DEPARTMENT OF TRANSPORTATION

Federal Motor Vehicle Safety Standards; Child Restraint Systems, Child Restraint Anchorage Systems

ACTION: Final rule, response to petitions for reconsideration.

Figure 17- Side, Back and Bottom Views, ISO 13216-1 Static Force Application Device 2 (SFAD 2)

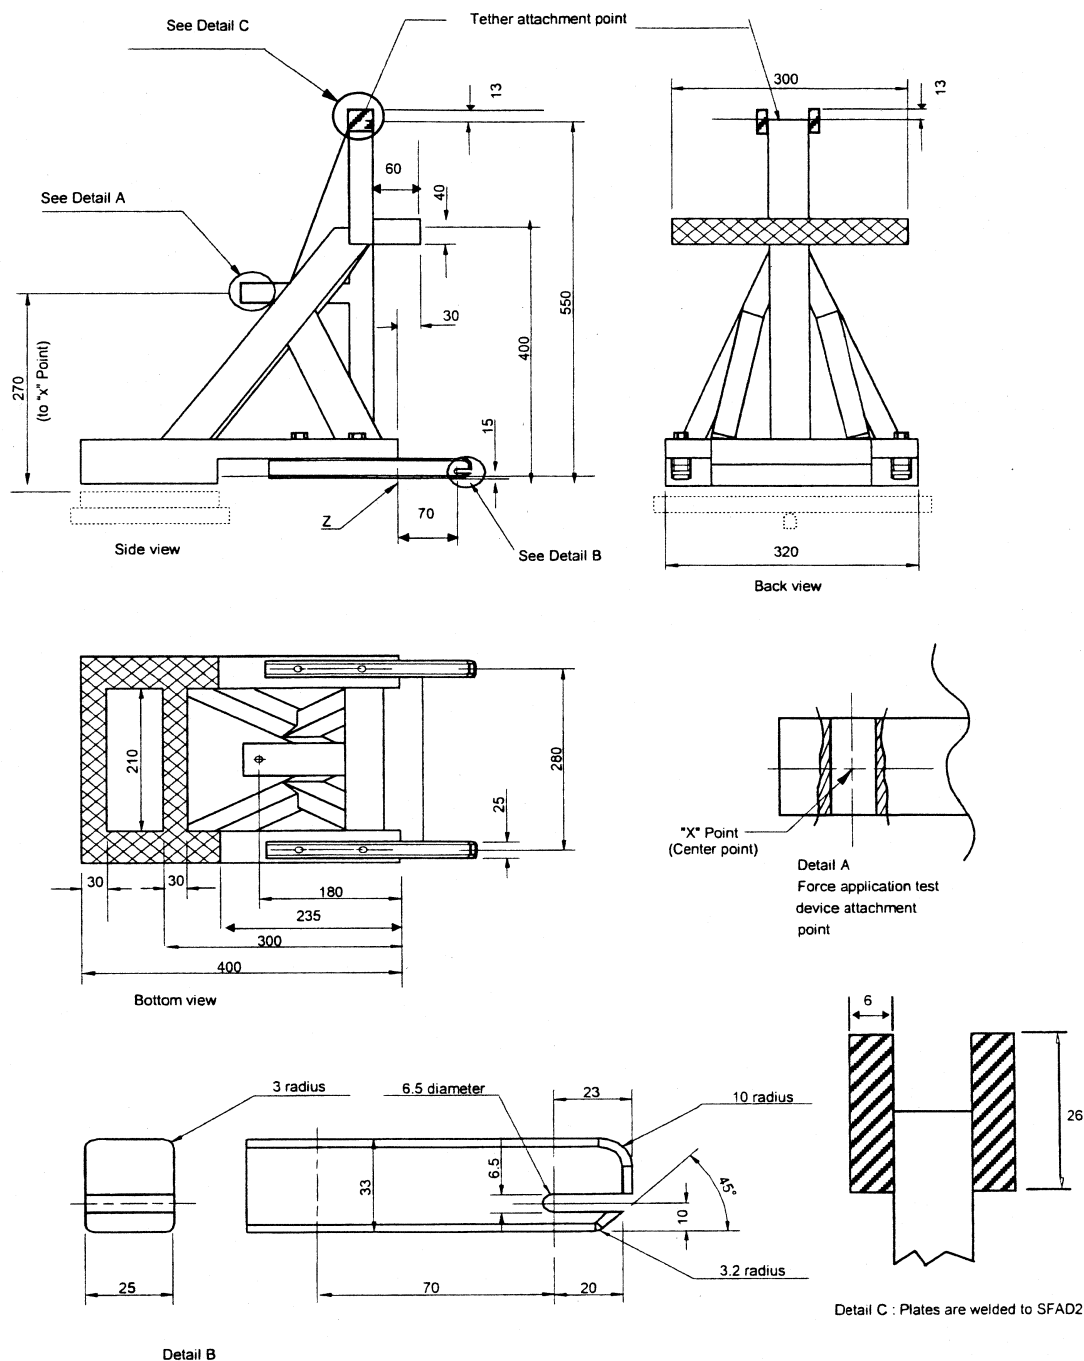
i. SFAD 2. In a petition for reconsideration, Mitsubishi noted that Figure 17 of FMVSS No. 225, which depicts the dimensions of the SFAD 2 test device, only specifies a tether attachment point somewhere near the top of the device. Mitsubishi believed that leaving the specific location of the attachment point and the shape and radius of the hole to the discretion of each vehicle manufacturer and test laboratory will lead to wide variation in the loading conditions in tether anchorage testing. Mitsubishi requested NHTSA to identify specific requirements for the location and dimensions of the SFAD 2 tether attachment point.

We have revised Figure 17 to make it clear that the tether attachment point on SFAD 2 is the same as on the SFAD 1 test device depicted in Figures 12 to 15 of FMVSS No. 225, both in location and dimension.

Figure 21—Length of Lower Anchorages

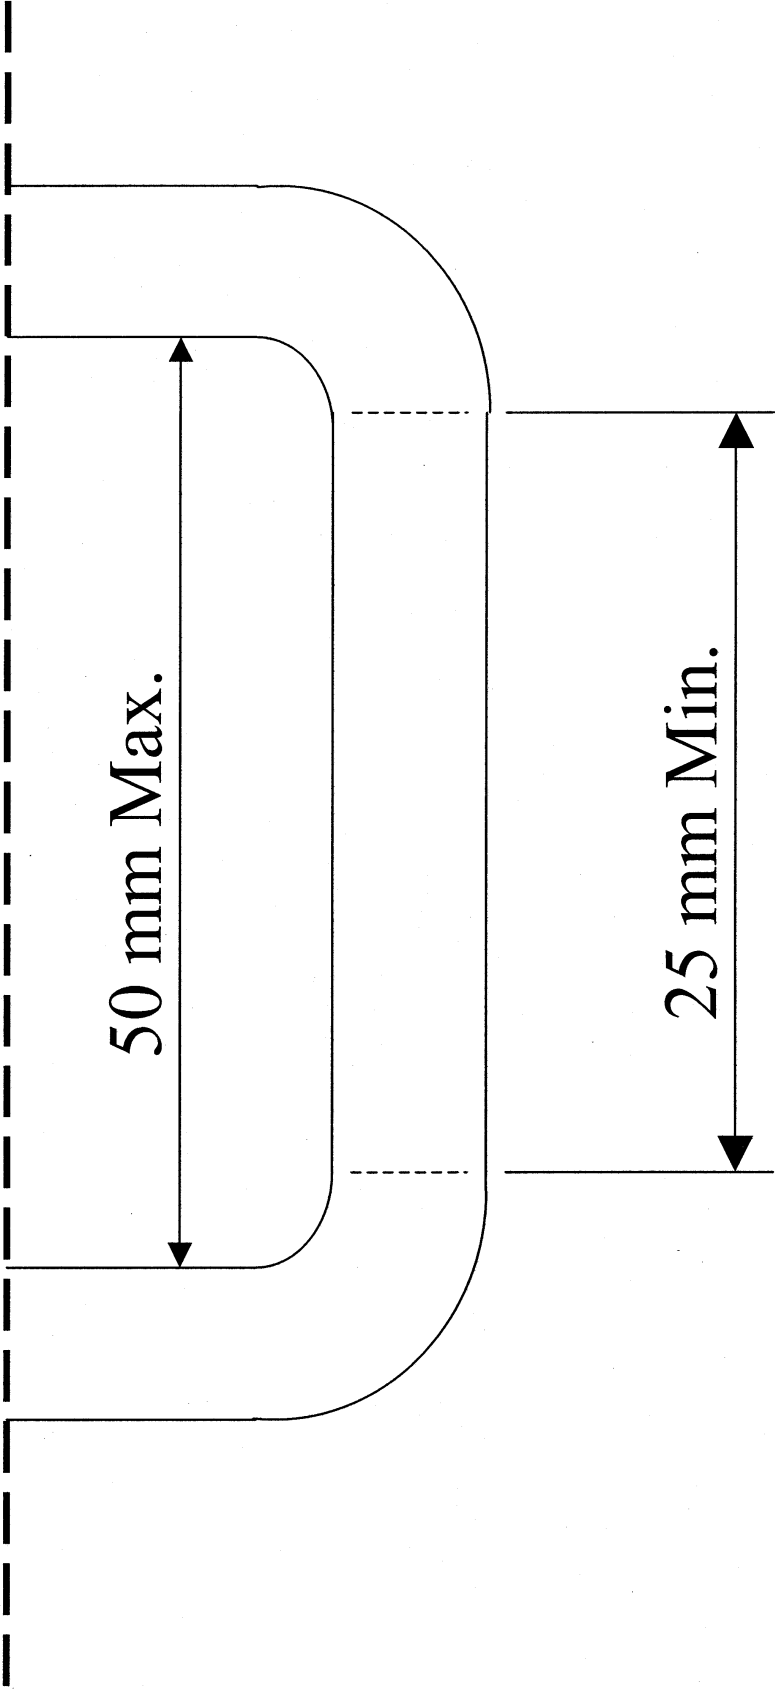
Bornemann Products Incorporated asked whether the "not less than 25 mm but not more than 40 mm" language in S9.1.1(c) refers to the inside opening of the anchorages (bars), or to the overall length of the bar including the 6 mm steel material. The answer is the inside opening of the bar, and not the overall length of it. We are adding a figure to the standard to clarify the meaning of S9.1.1(c).

(c) Are not less than 25 mm, but not more than 50 mm in length (as shown in Figure 21);

Figure 22. Placement of Symbol on the Seat Back and Seat Cushion of a vehicle

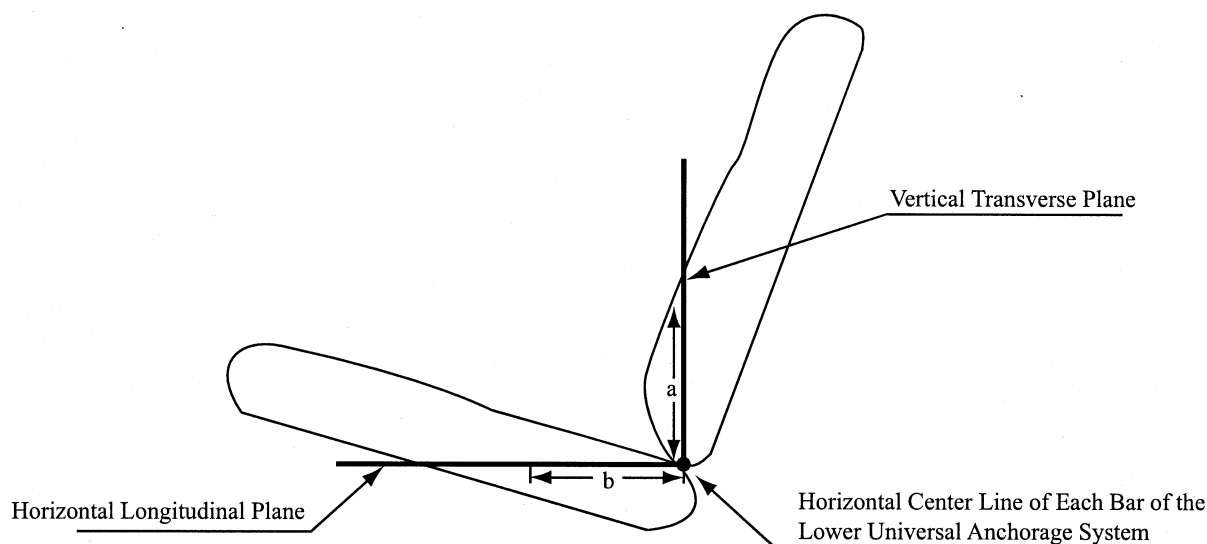
Mitsubishi believed that consumers would be better assisted in locating the anchorage bar if the 50 mm lower limit for location of the anchorage bar mark were eliminated. The Alliance believed that the vertical position of the marking should be less restrictive than what the rule required. "It should be visible at a 30 degree viewing angle and be located no more than 100 mm from the horizontal centerline of the anchorage bar in the vertical longitudinal plane." Mitsubishi and the Alliance asked where the "seat back" begins for the purpose of marking the lower anchorages on highly contoured seats. Mitsubishi stated that the bottom cushion of some of its seats curves toward the vertical and supports a portion of an occupant's lower back before a separate seat back begins. Petitioner stated that if the agency considers a portion of a vehicle seat to be the seat back solely by reference to a physical separation between the bottom seat cushion and the seat back, the circle markings would be more than 75 mm above the anchorage bars, which is not permitted by S9.5(a)(3).

To make it easier to find where the circles should be placed, the agency is amending S9.5(a) to use reference planes developed by Transport Canada in Regulation 210.2, "Lower Universal Anchorage Systems for Restraint Systems and Booster Cushions" (Standard 210.2). That standard requires the markings to be on the seat back between 50 and 75 mm above or on the seat cushion 100 ± 25 mm forward of the intersection of the vertical transverse and horizontal longitudinal planes intersecting at the horizontal centerline of each lower anchorage. This approach is not only clearer in where the circles should be, but also permits the markings to be located either on the seat back or the seat cushion, which allows flexibility to manufacturers such as Mitsubishi with atypical seat designs. The area 100 ± 25 mm forward of the

intersection of the planes is specified to account for the lower anchorage bars being recessed in the padding of the seat back or recessed in the seat bight. This final rule incorporates a figure (Figure 22) into the standard that illustrates the intersection of the vertical transverse and horizontal longitudinal planes.

(3) That is located such that its center is on each seat back between 50 and 75 mm above or on the seat cushion 100 \pm 25 mm forward of the intersection of the vertical transverse and horizontal longitudinal planes intersecting at the horizontal centerline of each lower anchorage, as illustrated in Figure 22. The center of the circle must be in the vertical longitudinal plane that passes through the center of the bar (\pm 12 mm).
